DTE Energy®

Meeting with NRC on RAI 10.04.07-1
Regarding Condensate & Feedwater
Supplemental Information

December 13, 2011

Figure 10.4-6a. Low Pressure Extraction Steam System

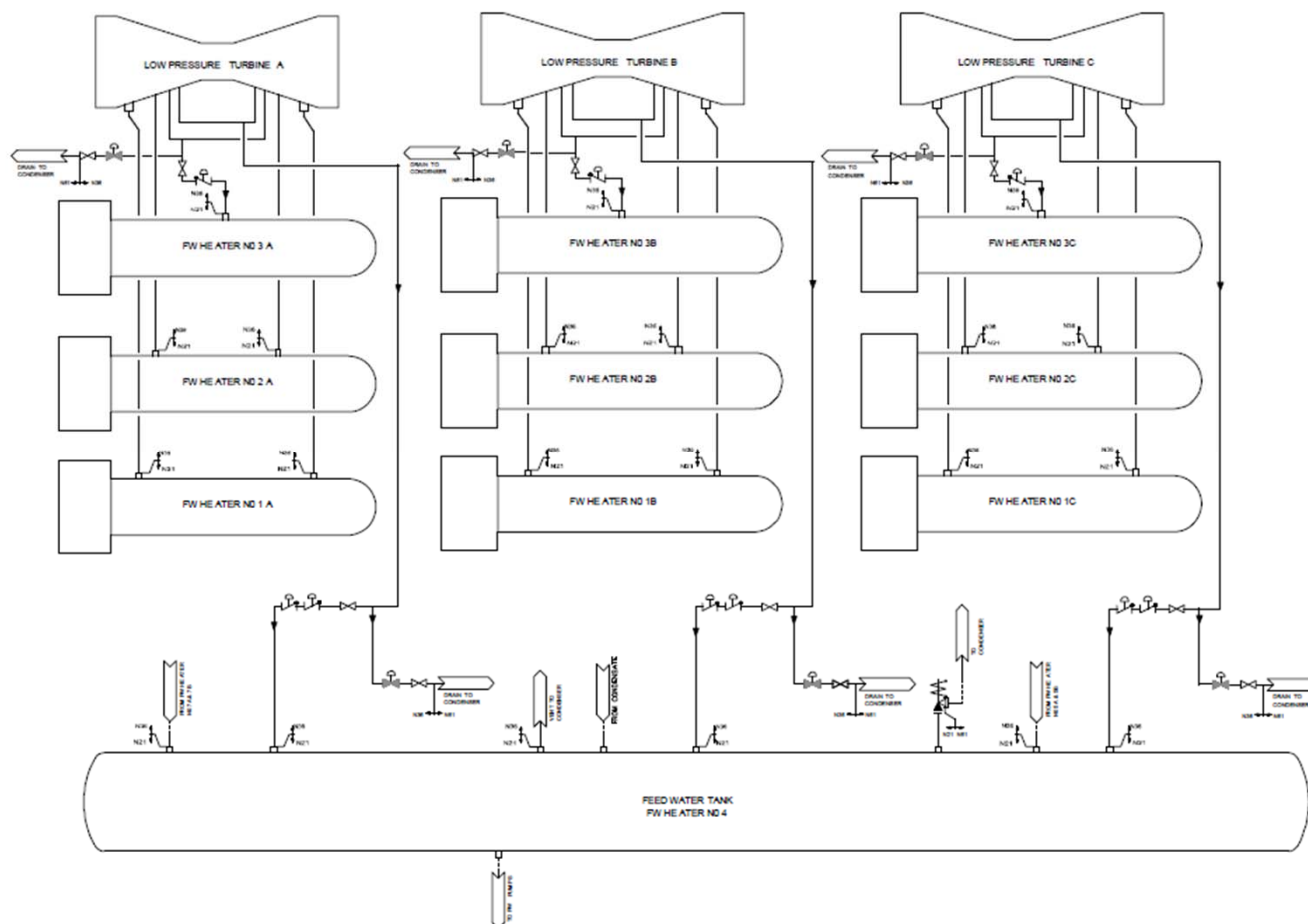
ESBWR Design Features

- RG1.206 defines a departure as a deviation from design information in a standard design certification rule.
- FSAR Chapter 10 information specifies supplemental detailed BOP system design capabilities for Fermi 3. The supplements do not deviate from the DCD standard design but provide more detailed site-specific design information to ensure sufficient capacity is available for cascade operation.
- The following slides show DCD design information for (1) operating in the cascade configuration within the feedwater operating domain and (2) the system components available to align heater drains to the condenser.

Figure 10.4-7b. High Pressure Drain and Vent System

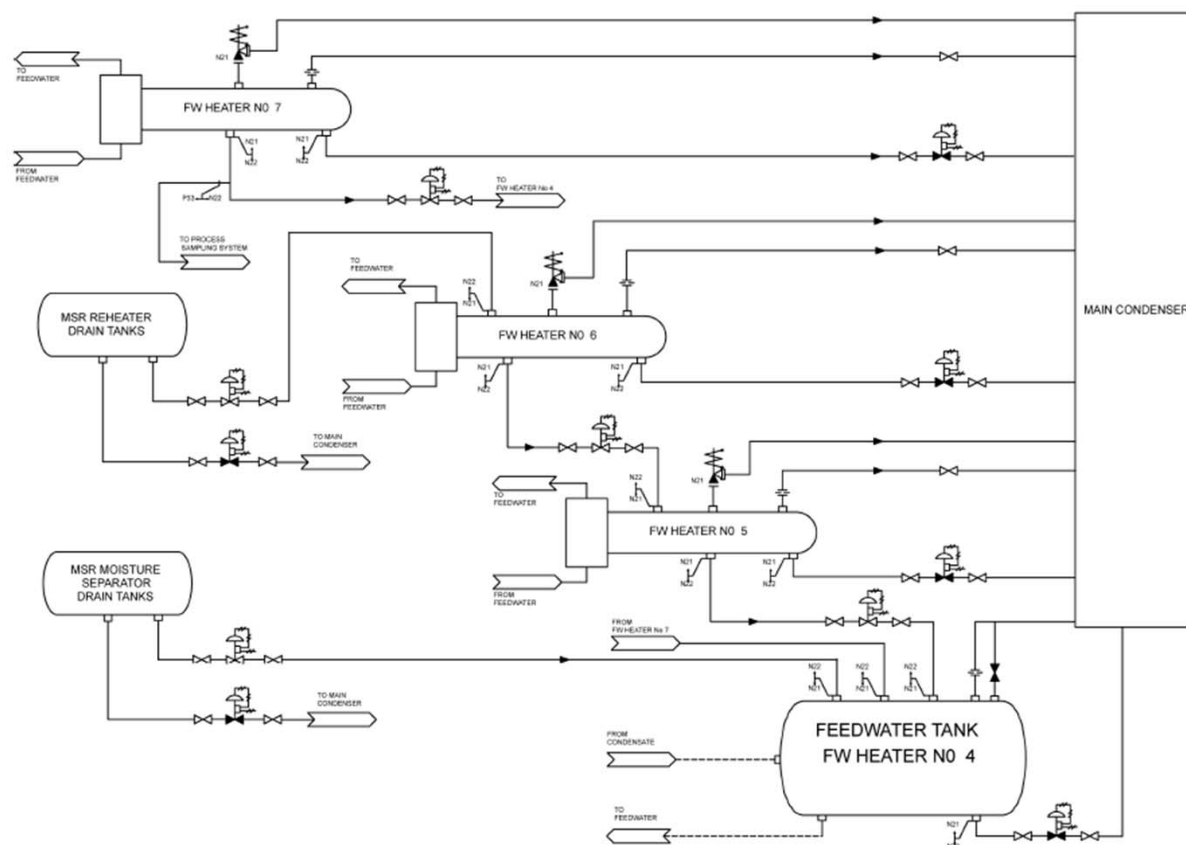
ESBWR Design Features
